Applicant: David Long; Twin Cities and Western Railroad Company
Consultant: Jeff Cooley; Civil Design, Inc.
Project: Railroad Track Additions and Culvert Improvements
Location: 6282 Industrial Drive, Eden Prairie, MN
Applicable Rule(s): 2, 3, 4, 5, 6 and 7
Reviewer(s): Louise Heffernan and Bob Obermeyer; Barr Engineering Co.

Figure 2. Proposed Culvert Improvement Locations.

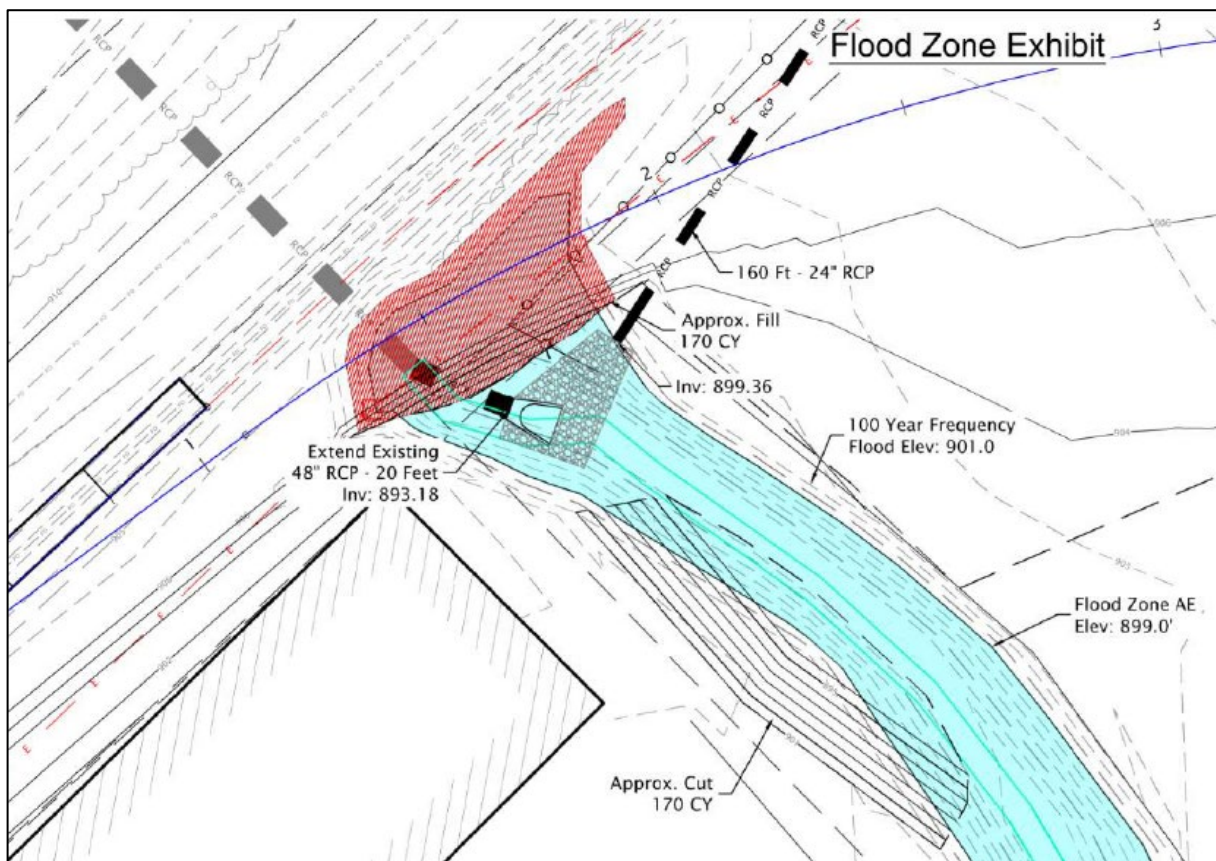
The District's Waterbody Crossings and Structures Rule 6.0 applies to the project because a new 24-inch RCP culvert and a 20-foot, 48-inch culvert extension will be installed in the bed and/or bank of the creek. Conformance with Rule 6.3 criteria is required. The locations of the proposed culvert improvements are shown in Figure 2 below.

Because a new 24-inch RCP culvert is proposed to be installed in the bank of the creek and a 20-foot extension to the existing 48-inch RCP culvert is proposed to be installed in the bed of the creek, the improvements must retain adequate hydraulic capacity and assure no net increase in the flood stage of the creek. The plans indicate that the 20-foot extension will be installed at a 20-degree bend to promote alignment of the 48-inch crossing with the creek bed, improving the hydraulics of the system.

Rule 6.3.1c criteria is addressed in *Section 2.0 Floodplain Management and Drainage Alterations* of this report. To conform to subsection 6.3.1c criteria, the potential erosive outlet velocity from the proposed 24-inch RCP outlet must be reduced, as outlined in

the *Recommendations* section of this report. A reduction in the outlet velocity may require that a drop manhole be installed along the pipe alignment and/or an increase in the outlet pipe size (i.e., a 36-inch pipe to the creek). Additionally, it is recommended that the 24-inch outlet invert be installed at the thalweg of the creek with the outflow discharge directed along the flowline of the creek to prevent water quality degradation.

To conform to NMCWD Rules 2.3.3 and 6.3.1c criteria, the potential erosive outflow velocity (8.8 ft/sec) from the proposed 24-inch RCP outlet must be reduced. Outflow velocity reduction may be achieved with the installation of a drop manhole structure along the pipe alignment with an increase in the outlet pipe size (i.e., a 36-inch pipe to the creek). Additionally, to prevent erosive forces along the bank of the creek and water quality degradation, it is recommended that the outlet invert be installed at the toe of the creek bank and directed down the flowline of the creek, per May 12, 2022 correspondence.
